PROJECT NO. ST87600114-3 GRAND CANAL BIKE AND PEDESTRIAN IMPROVEMENTS FEDERAL AID NO. PHX-0(BFG)F

ADDENDUM NO. 7

ISSUE DATE: October 4, 2017

___ 2.102 2.182

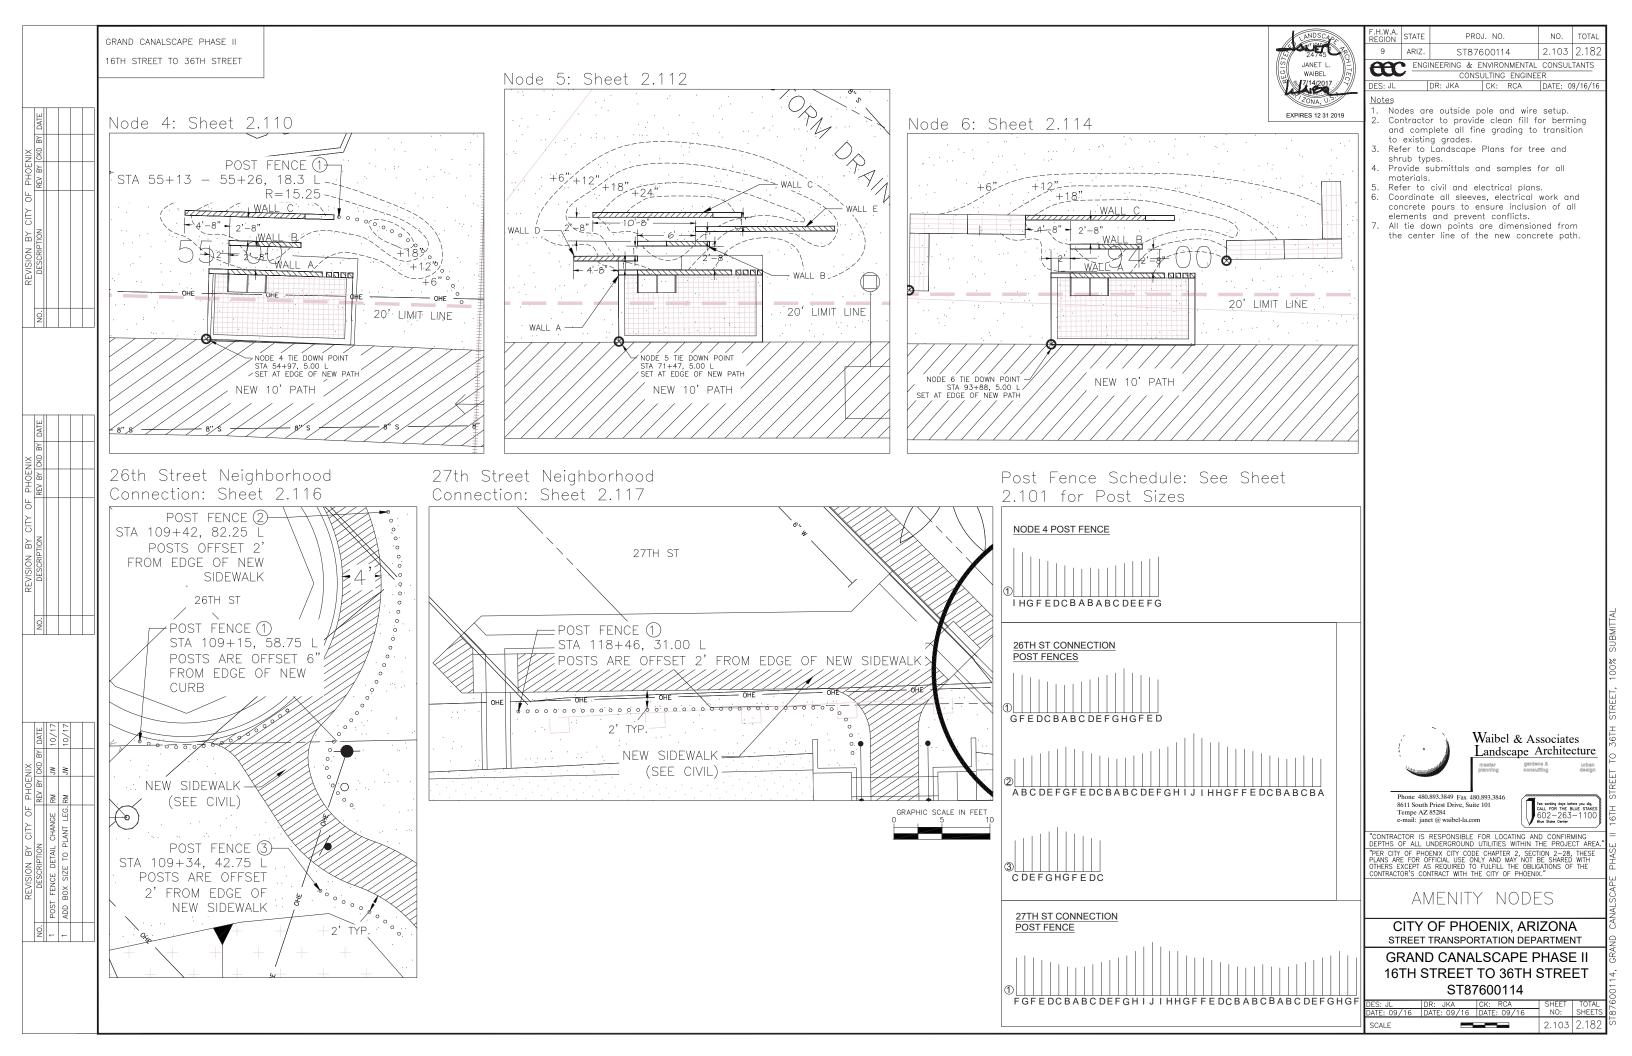
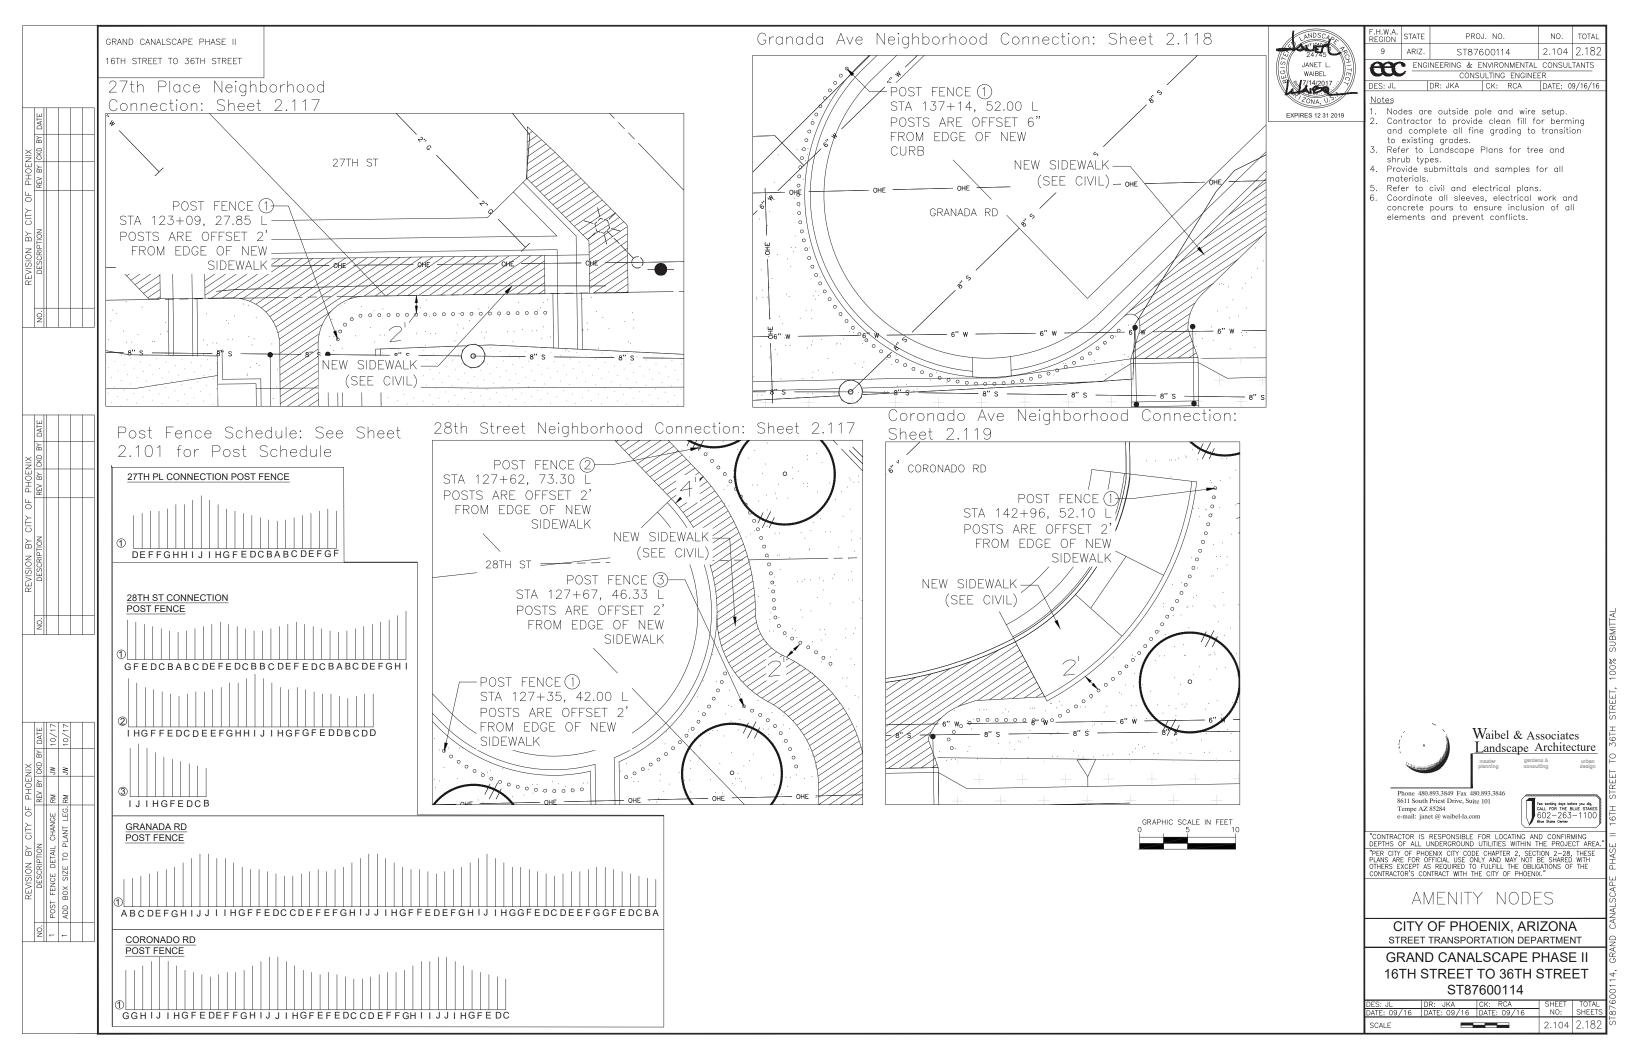
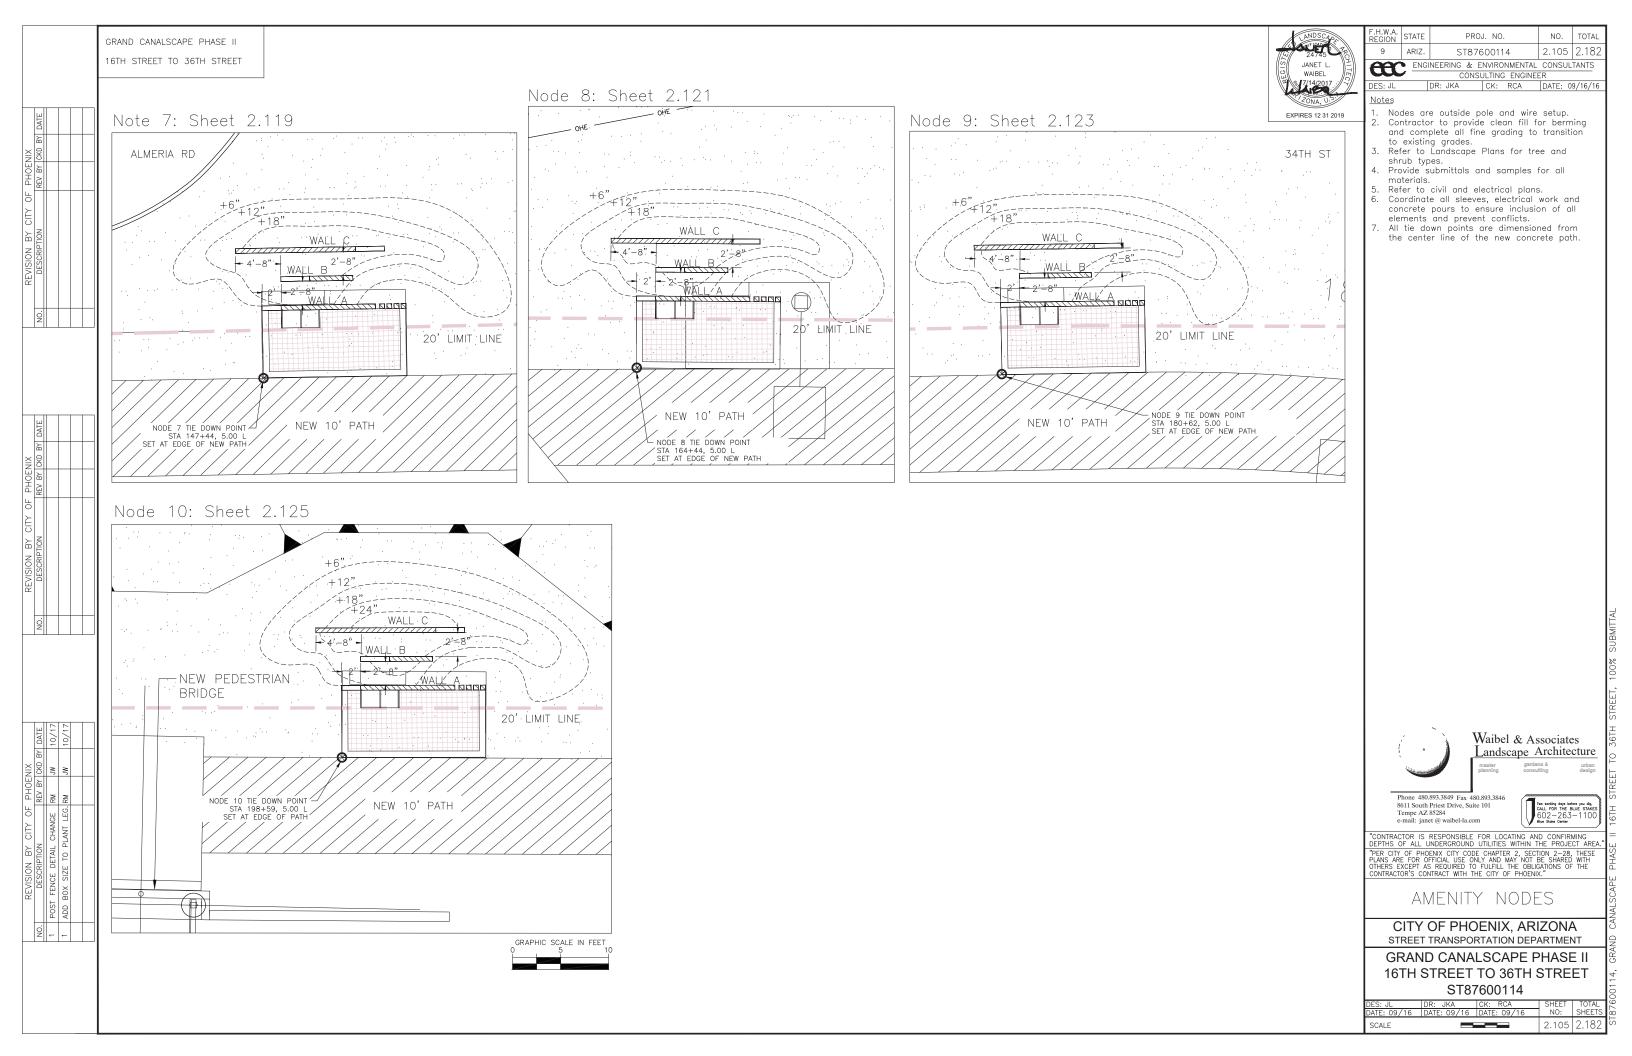
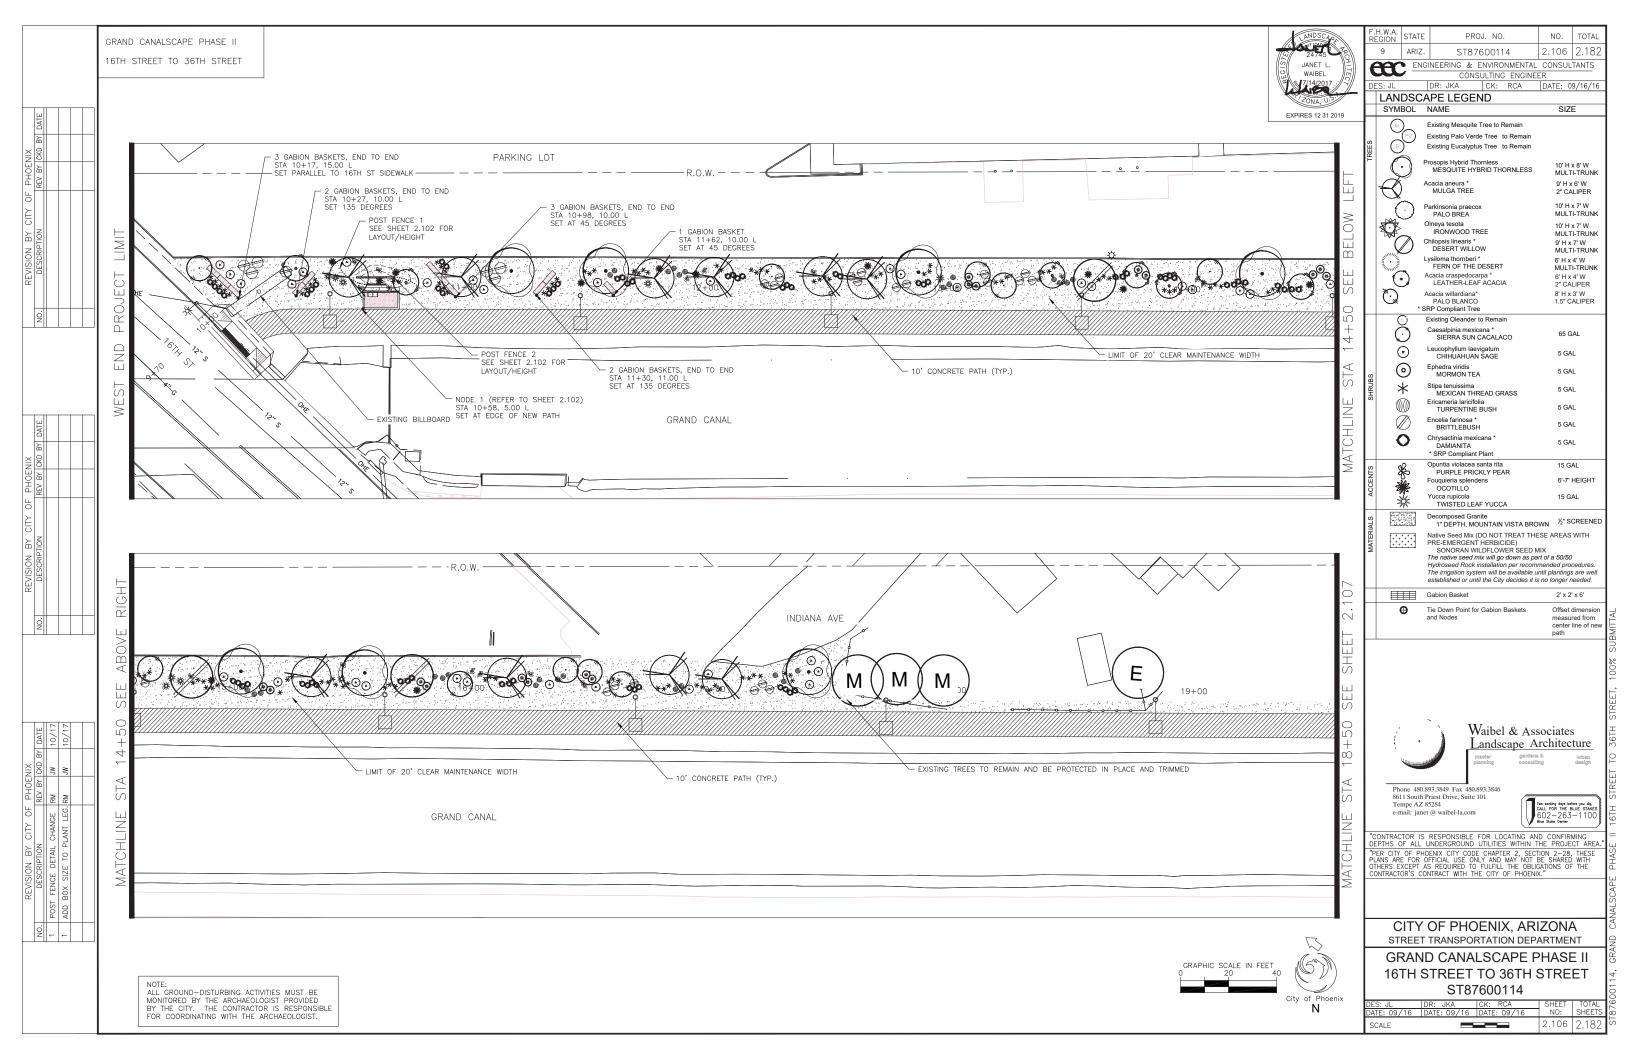
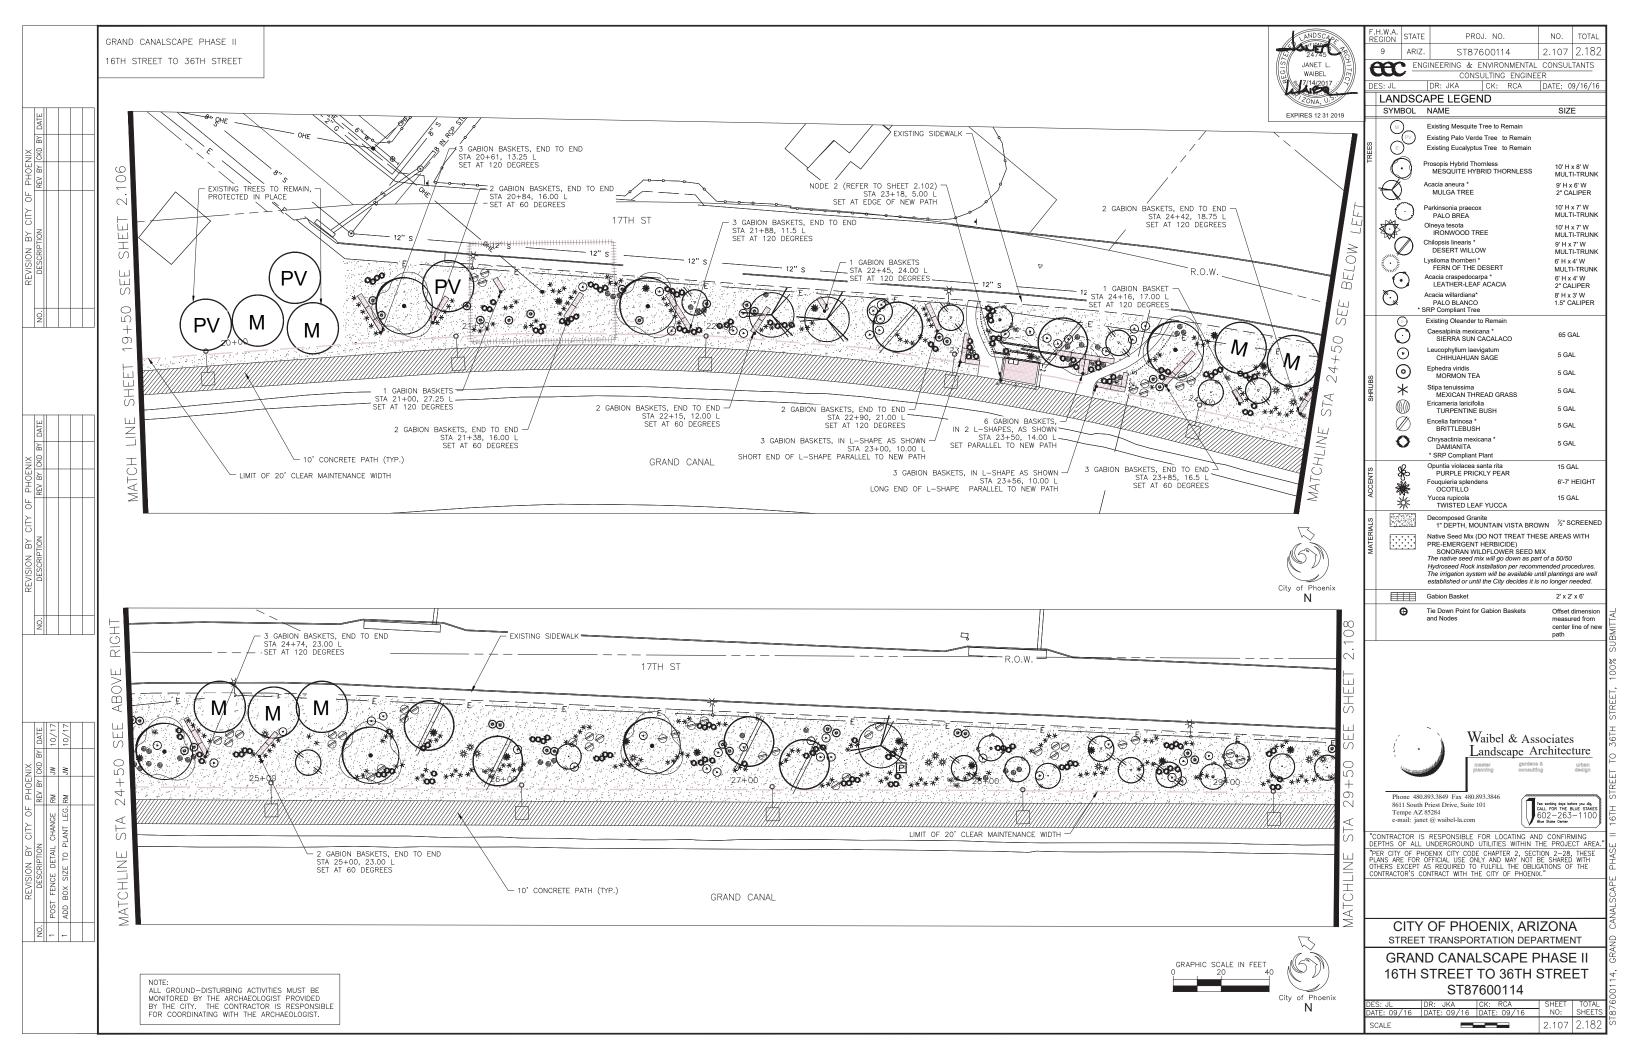
ALL NODES (EXCEPT NODE 2, SEE SHEET 2.102 FOR DETAILED DIM. (TYP.)
